Kinmel Bay Coastal Defence Improvements Scheme

Environmental Statement Addendum Final

October 2024

Figure 3-1: Location of new access point in relation to original proposals.

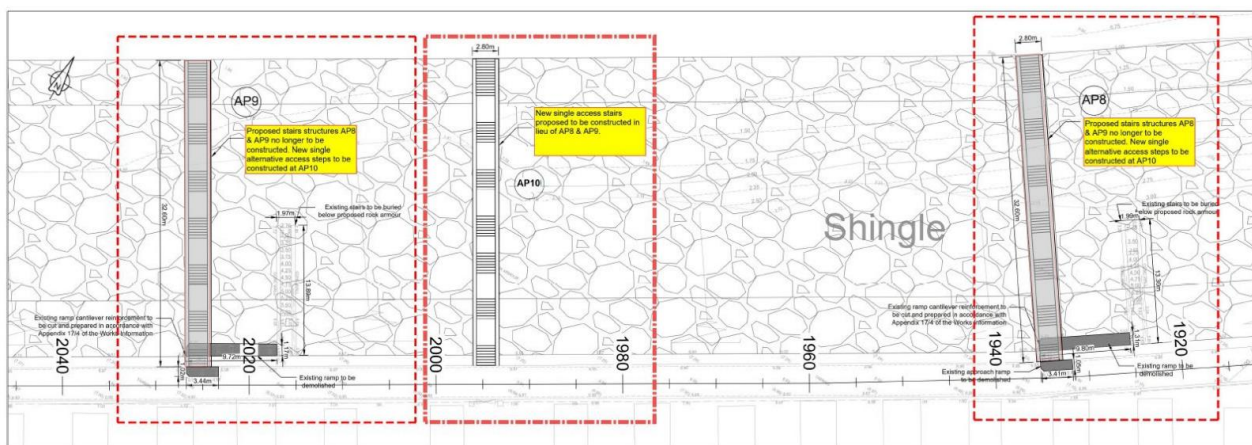
As part of the original application, two access points (AP8 and AP9) were proposed in front of Golden Sands Holiday Park. Following additional ground investigations and design development, two access points (AP8 and AP9) were substituted for a single central access point (AP10) shown on Figure 3-1. Originally, both access points in front of the Holiday Park required pilling, and the submitted ES proposed a press-in piling method which avoids impacts associated with noise and vibration.

However, the press-in piling method required the attendance of a large crane to mobilise and set up the piling and lift and position the sheet piles. It was deemed too disruptive to the community and adjacent caravan park to mobilise a crane in this area.

As this new access point (AP10) is located below MHWS, a temporary sheet pile cofferdam is required to provide safe and undisturbed access for construction of the access steps. This will enable the construction works and material deliveries such as a concrete to be

Figure 3-2: Plan view of proposed cofferdam layout.

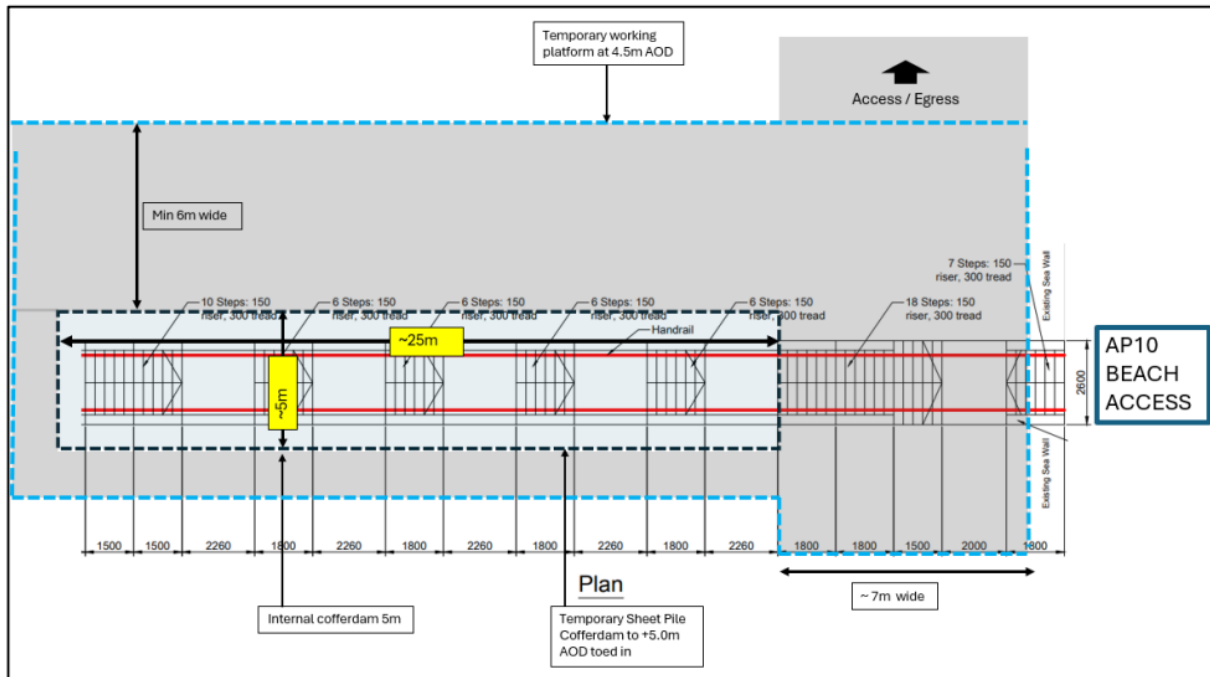
The temporary sheet piled cofferdam is yet to undergo detailed design, however, it is expected to be approximately 25m long and 5m wide, as shown in Figure 3-2 below. The sheet piles will be approximately 12m, with a maximum pile embedment of 9m into the ground.

The temporary sheet piles will be installed with a leader rig using a Vibro hammer. The leader rig will be able to access the working areas along the upper areas of the foreshore without any disruption to the local community and adjacent caravan park. The installation of the sheet piles will be undertaken from above MHWS on a high level temporary working platform adjacent to the existing sea wall.

The installation of the temporary sheet piles is expected to take 2 weeks, the removal is expected to take 1 week. If the project programme allows, neap tides will be targeted for installation and removal period to benefit from the increased distance from tide levels. We expect that the piles will be in place for approximately 16 weeks.
